TEKTRONIX INTERNAL USE ONLY

April 10, 1981
Issue 11-6

140 SERIES RTL LOGIC DEVICES

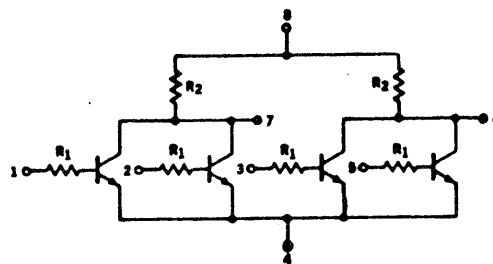
A recent question from the field concerning a possible ECB error on the 140 Line Timing board (670-0306-00) has brought up several problems.

1. If a Line Timing board is ordered, be aware of the possibility of an ECB defect connecting pin 2 (input) to pin 4 (ground) on U635A. Stocks should be checked for any further problems in this area.
2. The instruction manual (070-0944-00), diagram 6b, U635A shows pin 1 as the input to the IC. Correct this to read pin 2. Manual changes have been requested.
3. The IC used in U635 (156-0011-00) is used quite extensively throughout the instrument in a variety of configurations. The error in #2 (above) is not necessarily true in other parts of the manual. As shown below, the 156-0011-00 is a Dual-NAND gate and as such can assume a variety of logic uses depending upon connections used.

650 SERIES, RED CLAMP OSCILLATIONS

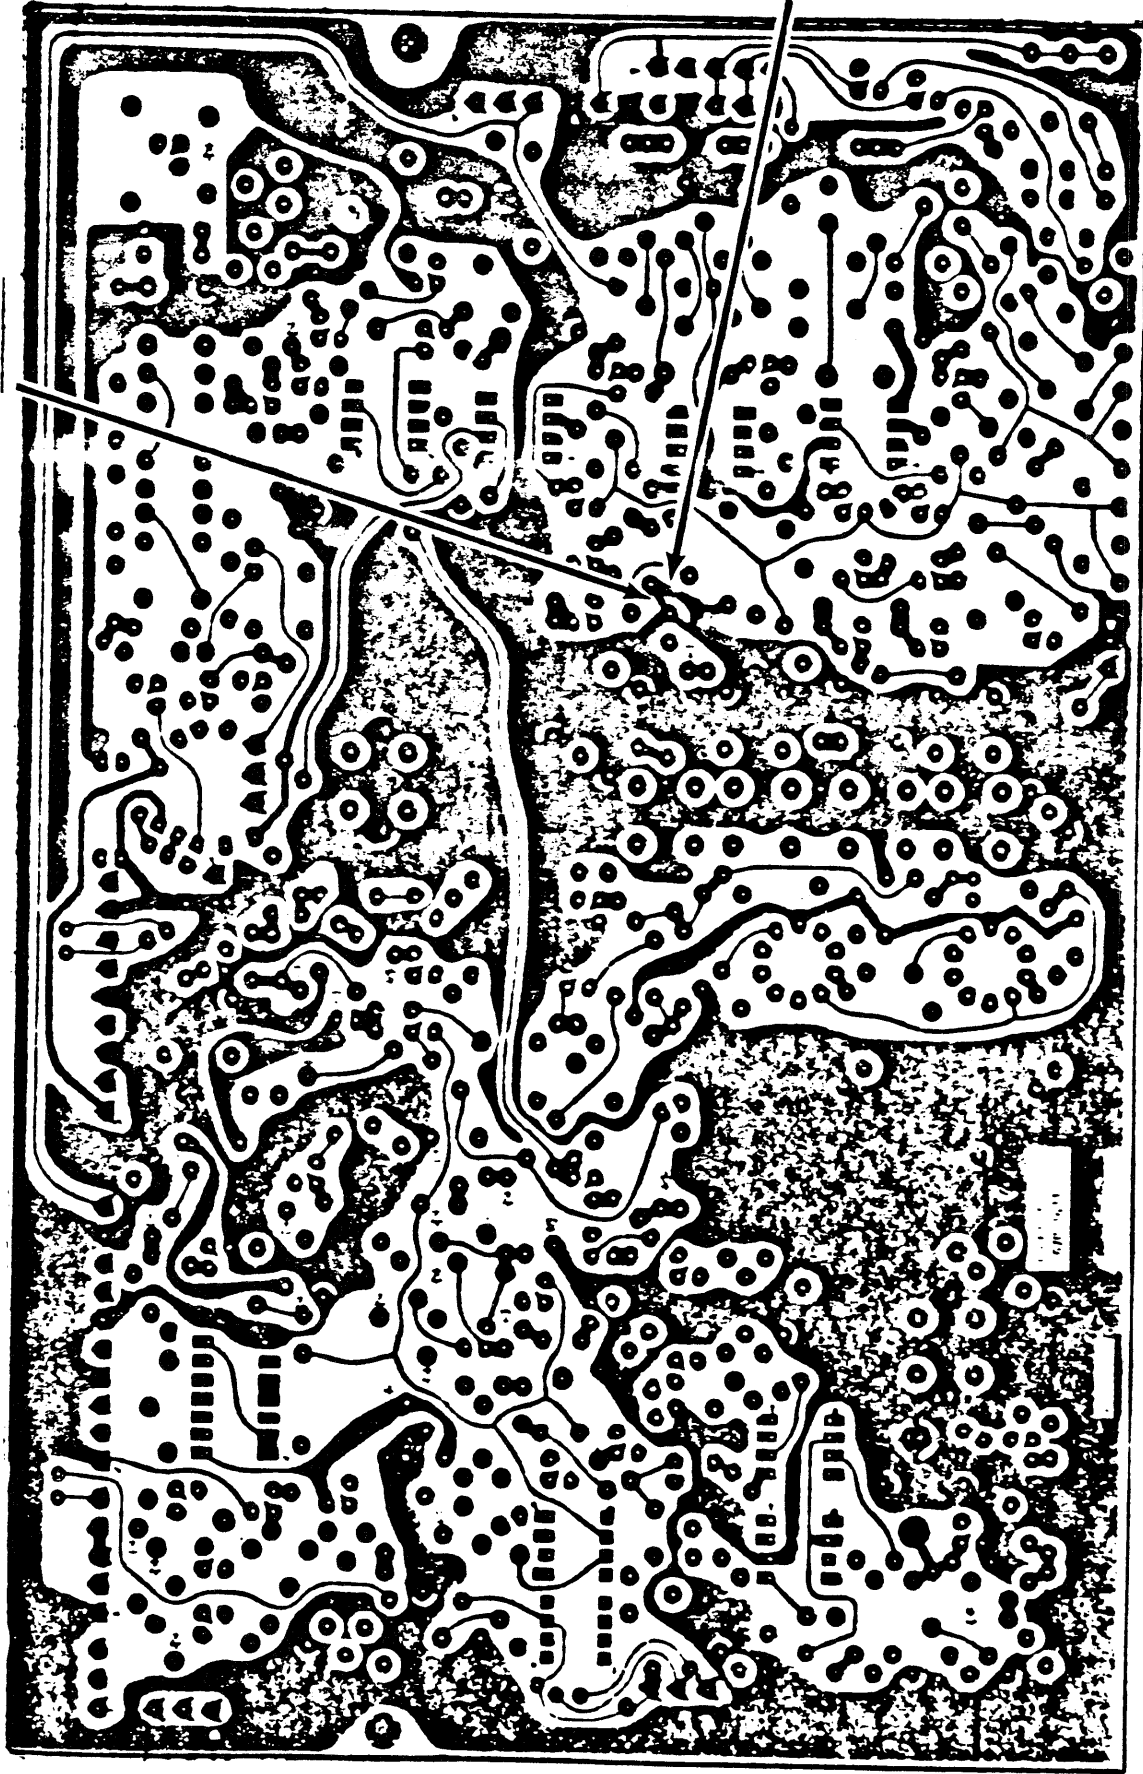
A circuit board error has been found in the listed products. The junction of R2739 and C2641 on the NTSC Decoder Board (670-2611-07) is connected to ground, causing an oscillation or "ringing" in the red clamp circuit. The defect is being corrected in manufacturing by cutting two circuit board paths as shown in the accompanying figure, pending a formal mod and ECB change. If red clamp oscillation is encountered in an instrument being serviced, insure this correction has been implemented prior to proceeding with further troubleshooting.

618 OPT 30 CABLE (012-0824-00)

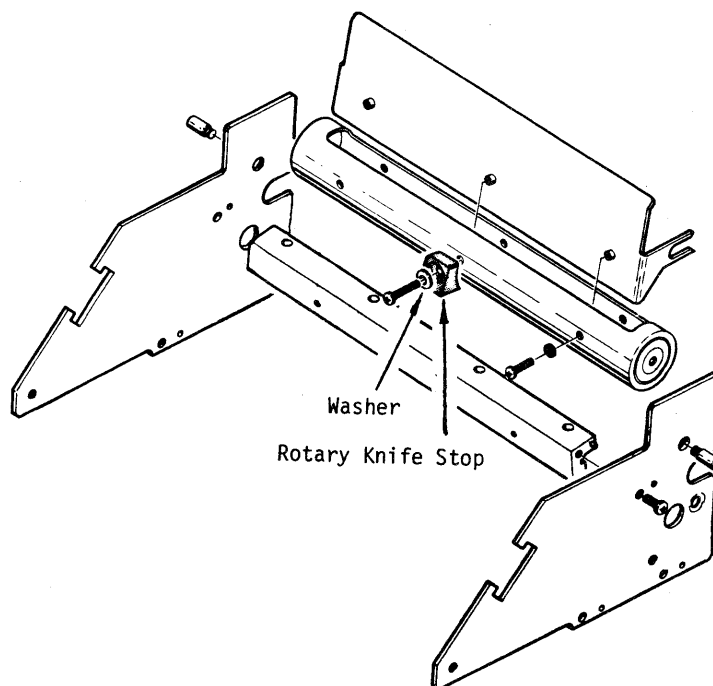
It has been brought to my attention by field service that some of the 618 Option 30 cables have been received by customers with pins in wrong locations. On the J1000 end pin 13 (+Y) is in pin 14 location and pin 17 (-Y) is in pin 18's locations. +Y should be in pin 13 and -Y should be in pin 17. Please see referenced manual, pages 2-19 and C-1.

When used with an IBM3277 in Self test mode, the symptom is a dot in the middle of the screen instead of a diagonal vector. Be aware that this problem will NOT show up when using the 067-0807-00 test fixture.

463X CUTTER CLUTCH CHATTER

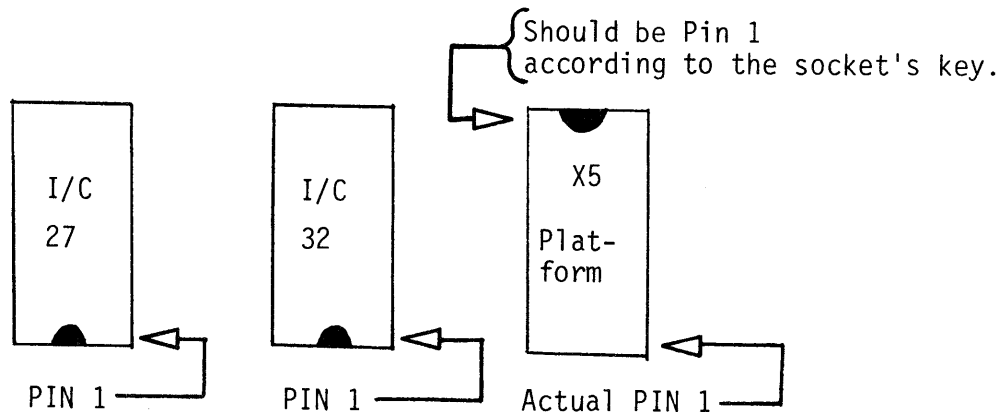
The 463X cutter clutch has been known to "chatter" with the paper cassette holder latched in place. The chatter disappears upon unlatching the holder.

The cause of the chatter is that the rotary knife stop (see figure below) is positioned too low. If the position of the stop is set too low, a constant downward force is put against the pin in the end of the cutter actuator. This in turn causes binding inside the clutch and produces the chatter.

To correct the problem, reposition the knife stop higher on the rotary blade. On earlier instruments where the 214-1932-00 actuator has been replaced by the 105-0781-00, it may be necessary to remove the washer in order to position the stop high enough to prevent chatter. Since the introduction of the new actuator with its greater range of motion, products have been shipped without the washer for just this reason.
